Location Address: GRIFFIN ROAD & SW 40TH AVE.

Explanation of Request: Preliminary Site Plan Proposed 5,411 SF Convenience Store with 20 fuel positions

**Re: Site Plan review for a service station (Racetrac).
File number 18-DSP-62**

The following is a response to staff comments. Below are the comments along with our responses in bold:

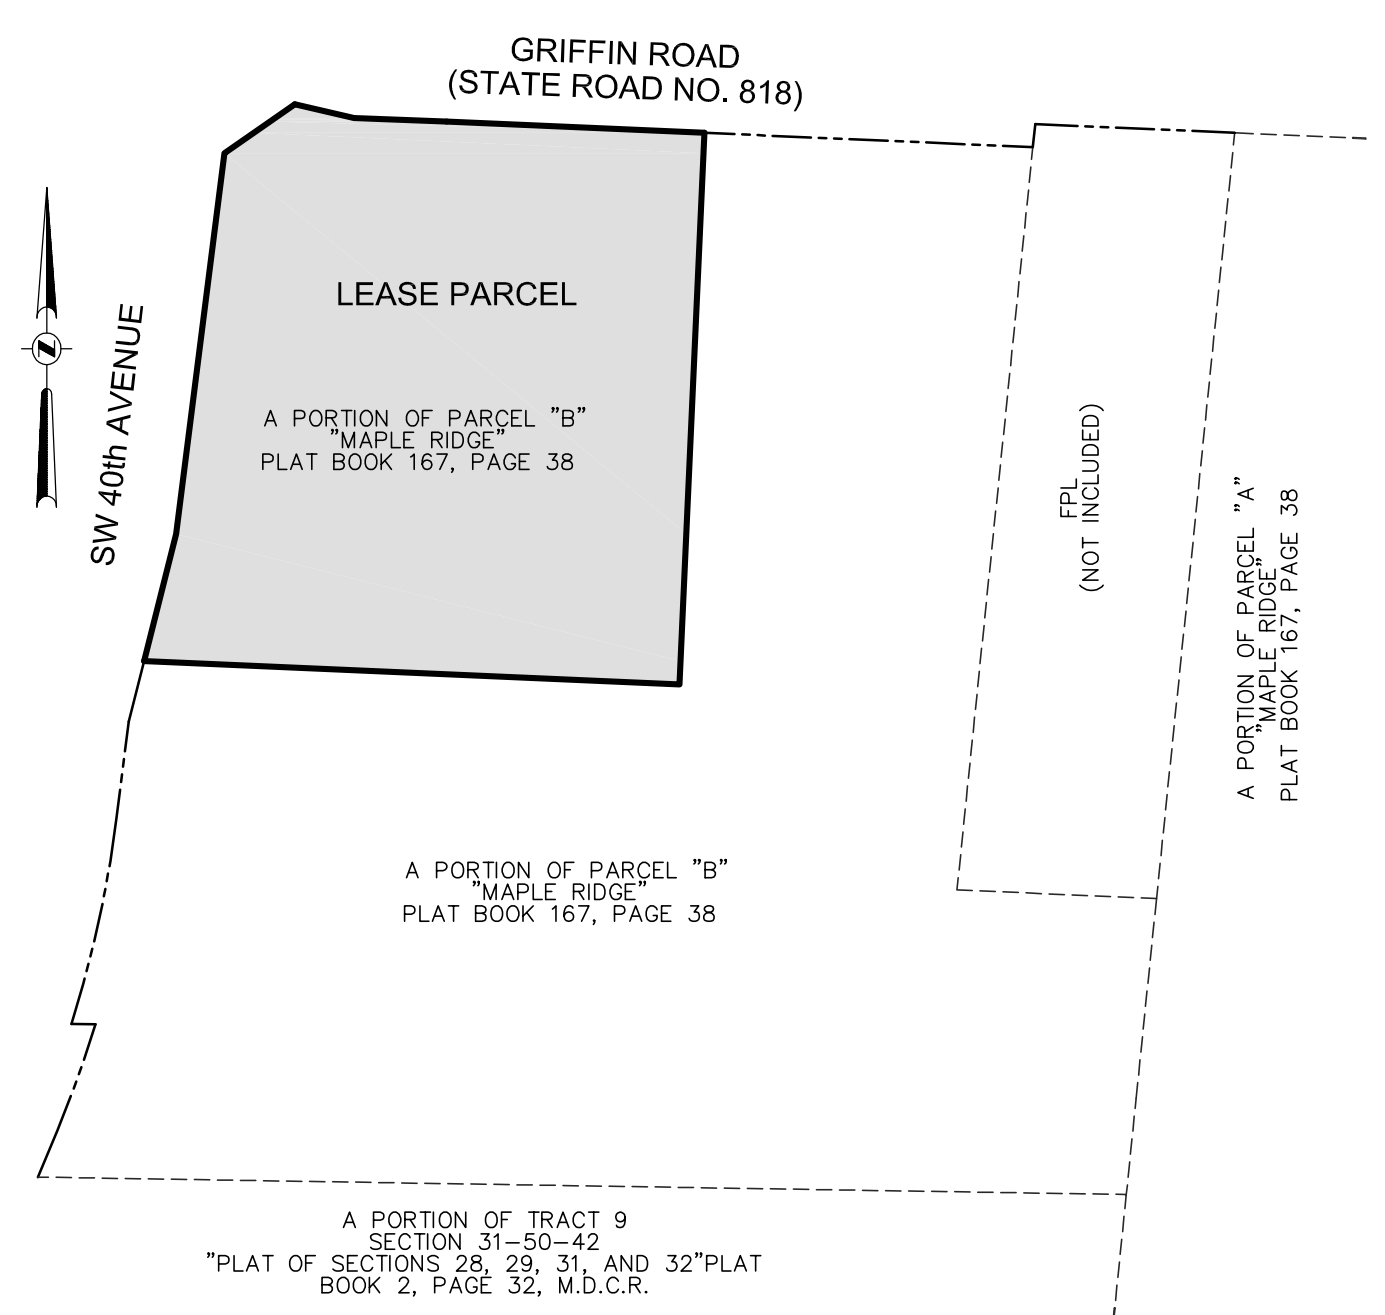
4. On cover sheet:
 - a. Indicate current and future meeting dates (not submittal dates) on Cover Sheet and Title Block. Indicate specific Board/Committee (i.e. Preliminary TAC, Final TAC, PDB, etc.). Be sure that all dates are accurately reflected. Leave space for future meeting dates.
 - b. Revise "Vicinity Map" to show boundaries on the property.

Response: A Site Plan Entitlement Meeting Schedule has been added to the Cover Sheet and the vicinity map has been revised to show the boundaries of the property. Refer to sheet C-0.

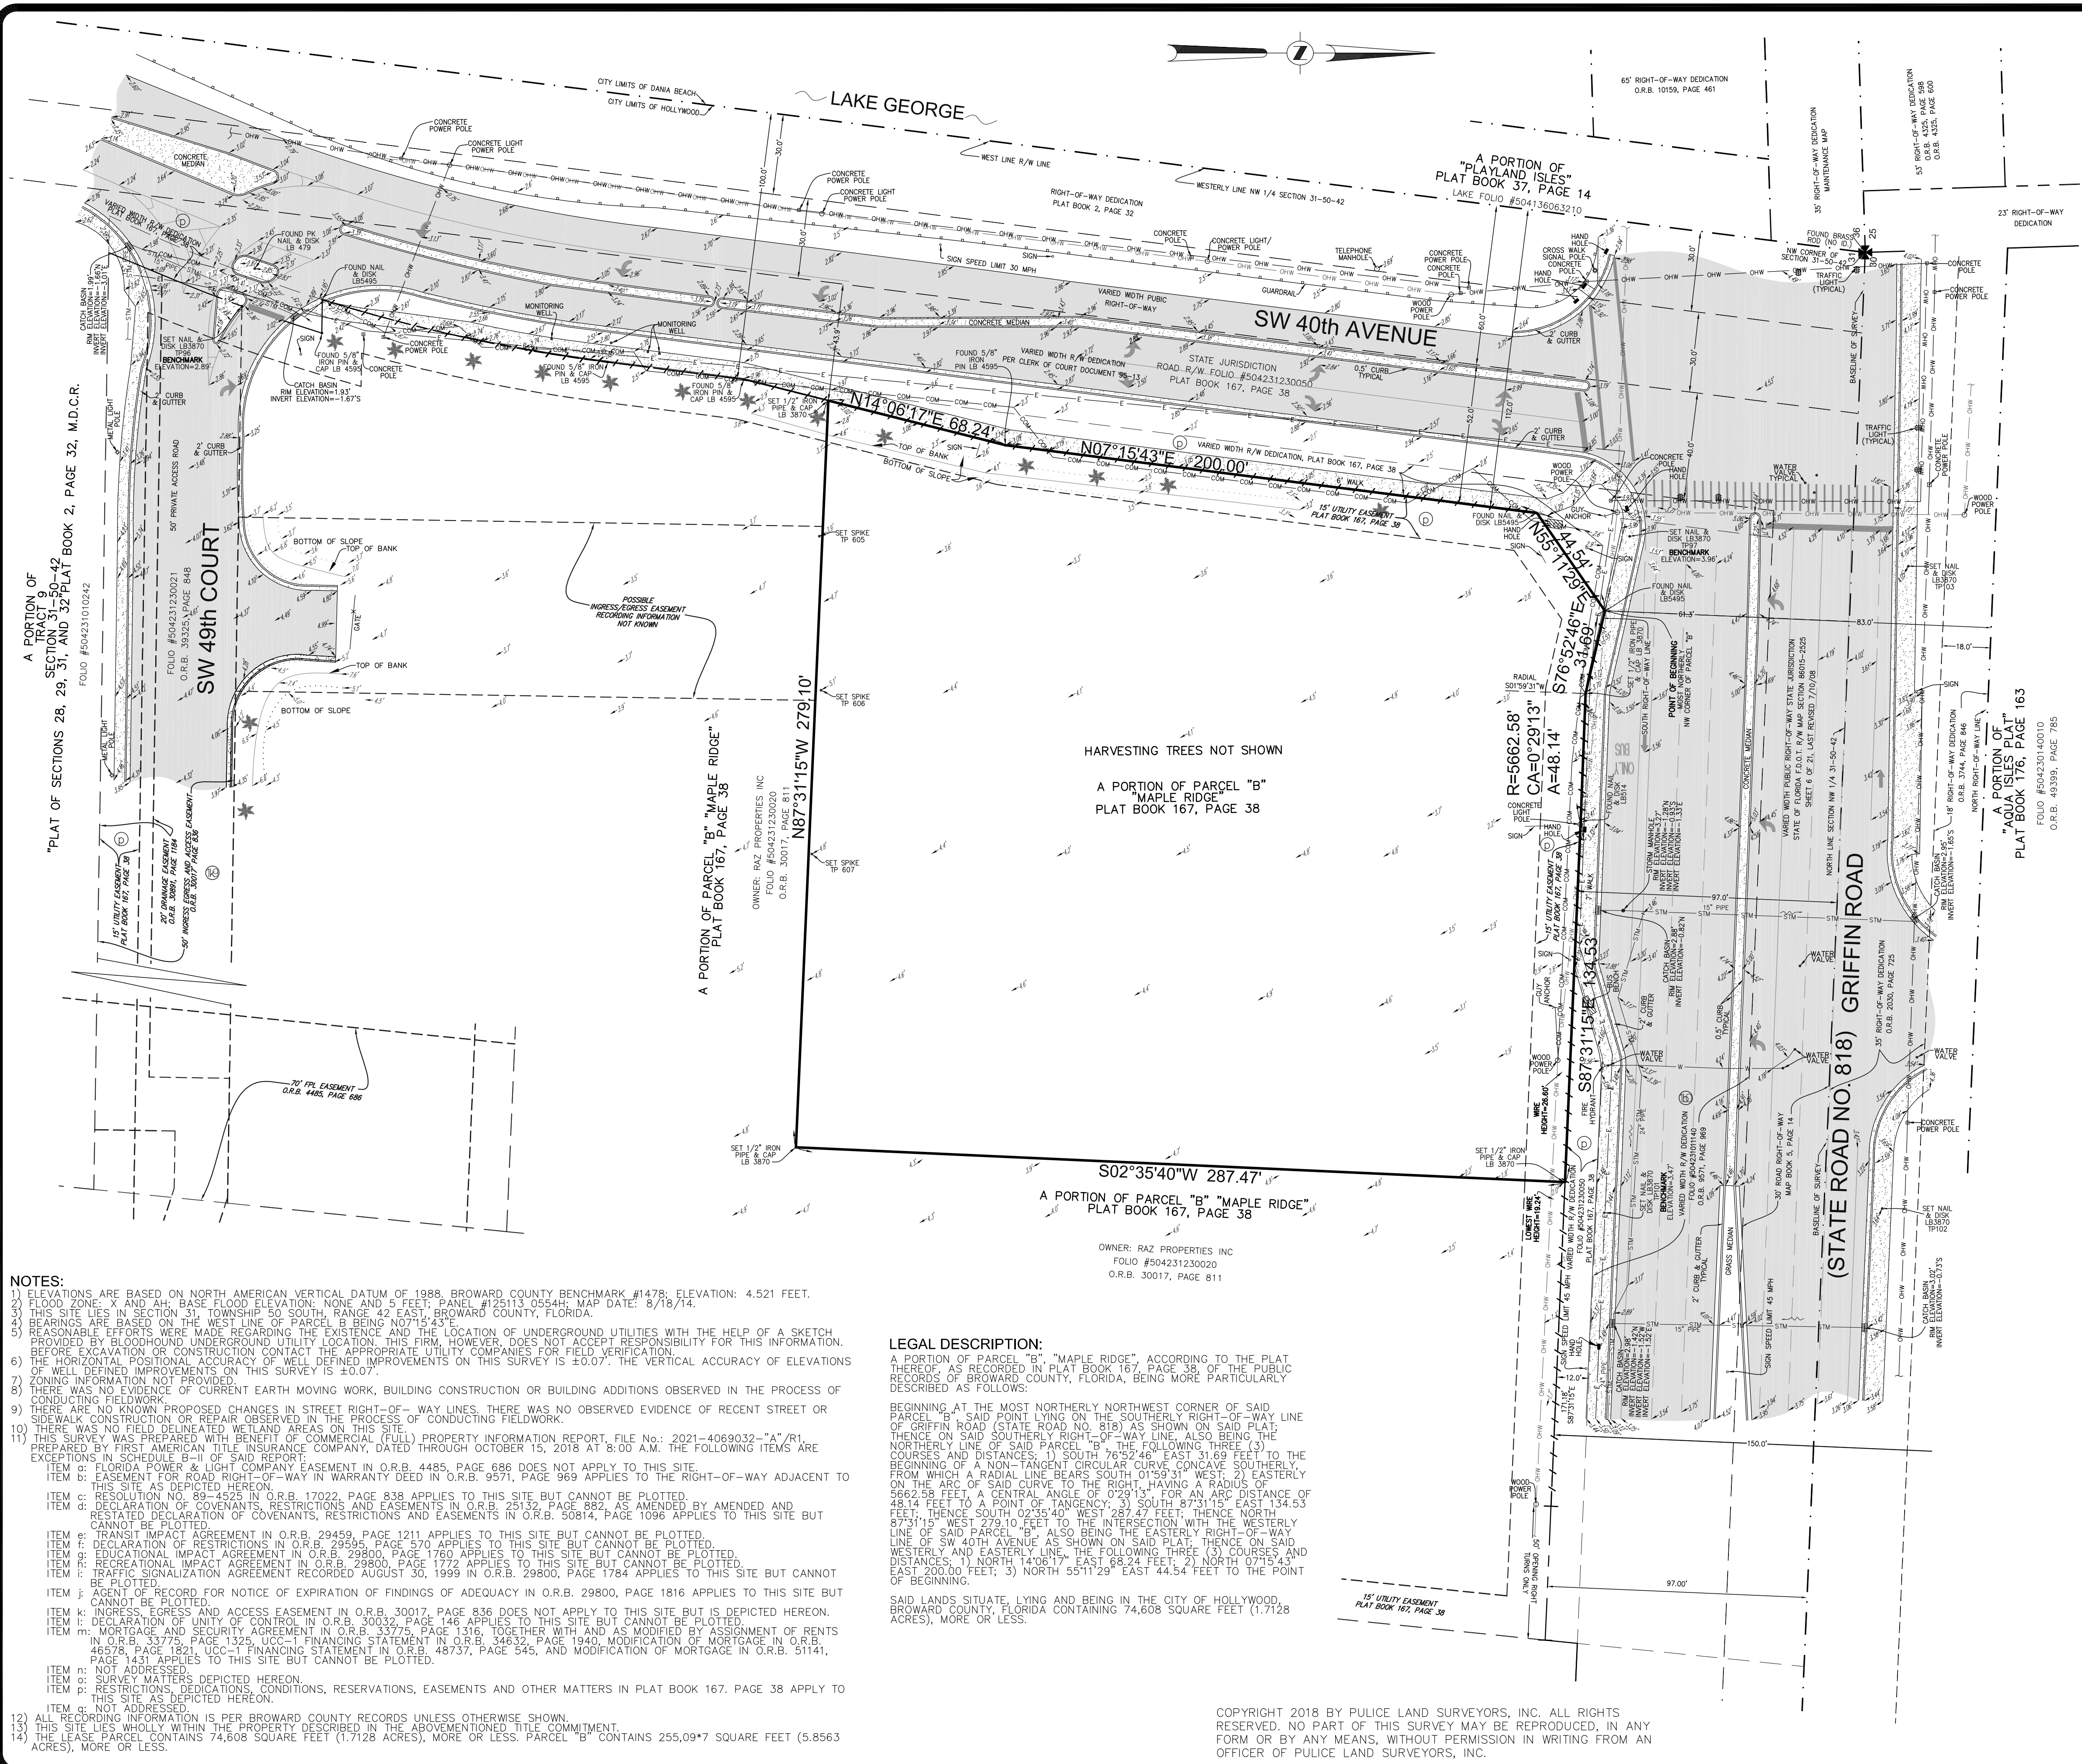
6. Ensure that survey and site plan include total lot area and not just area of proposed development. Ensure consistency between the two.

Response: Survey and Site Plan have been revised to match. Refer to sheets PLS-1 and C1.1.

SITE PLAN

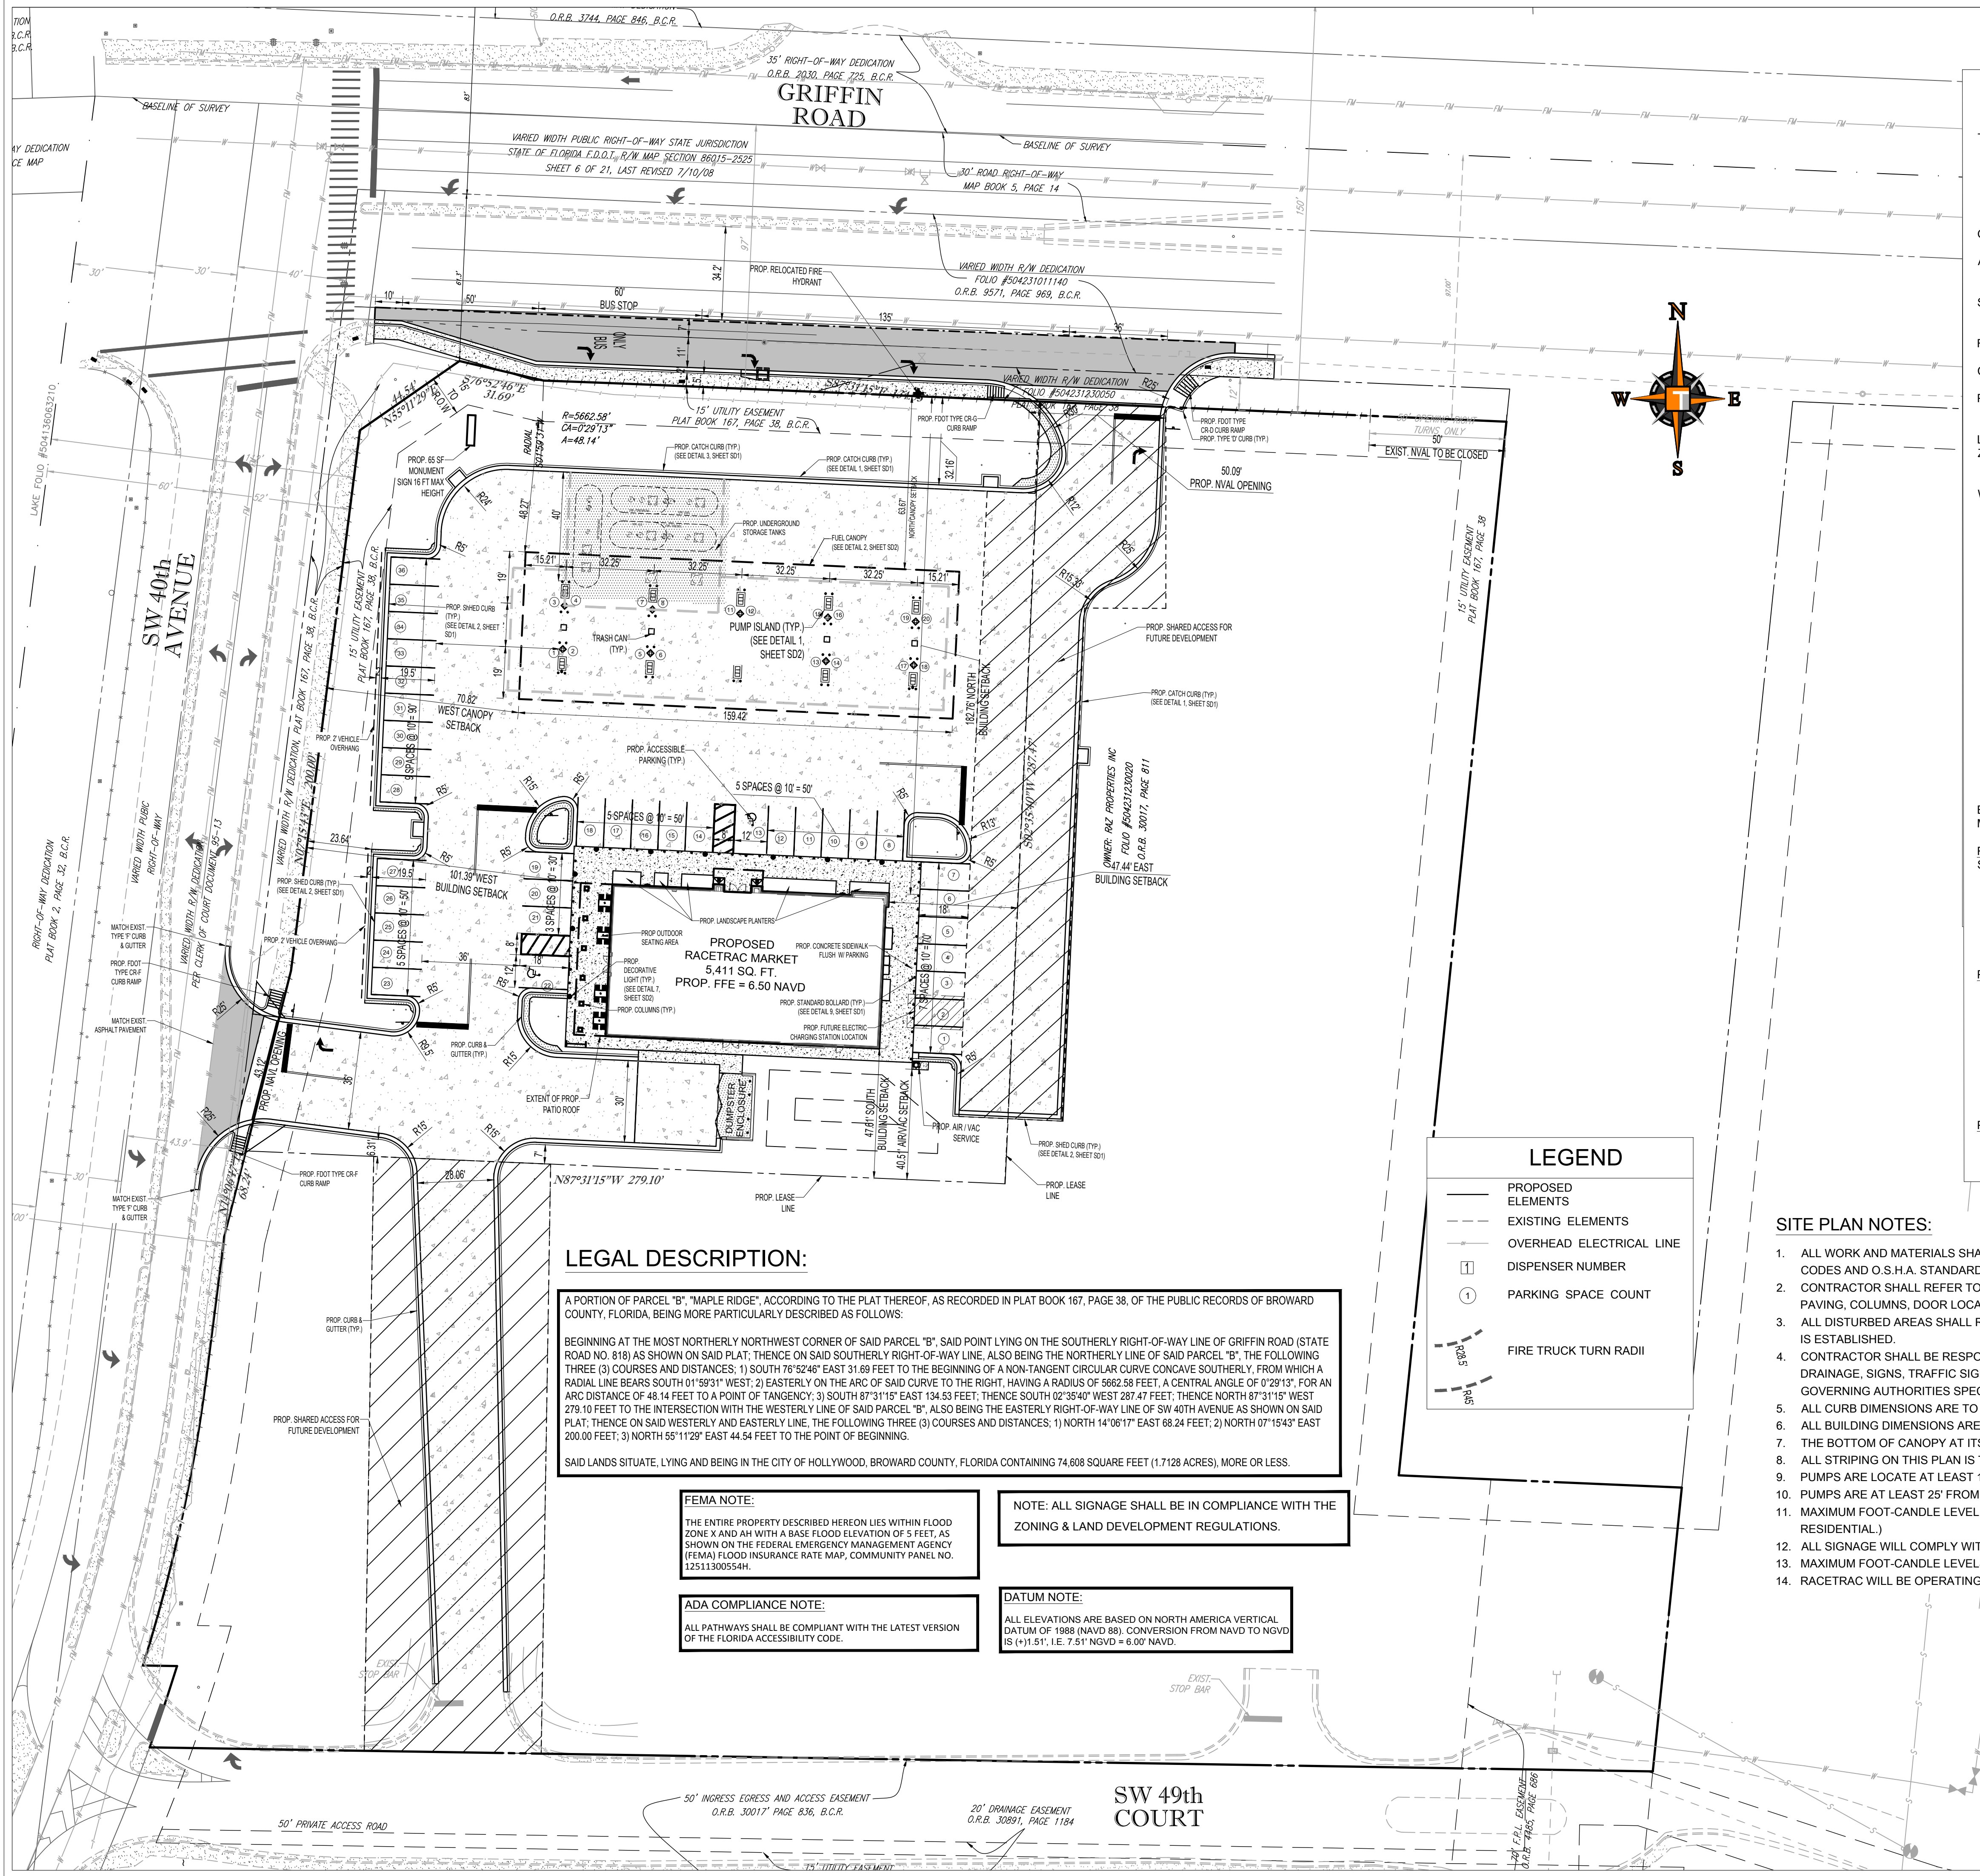
7. Provide note on plan:
 - a. Pumps are located at least 15' from any building base line.
 - b. Pumps are at least 25 feet from properties zoned residential.

9. Indicate on site plan two foot overhang for parking stalls. Please note that area within two foot overhang cannot be included in calculations for pervious area.

3. In the Site Data table on Sheet C-1.1, indicate the number of ADA accessible parking stalls required and provided.

1. Sheet C-1.1 – Seems like the project is over-parked?

Response: Notes have been added under the Site Plan Notes. Refer to the Site Plan on sheet C1.1.

Response: Overhang has been provided and pervious area has been revised. Refer to the Site Plan on sheet C1.1.

Response: Site Data table has been updated. Refer to the Site Plan on sheet C1.1.

Response: The applicant wishes to provide 36 parking spaces to accommodate the proposed RaceTrac.
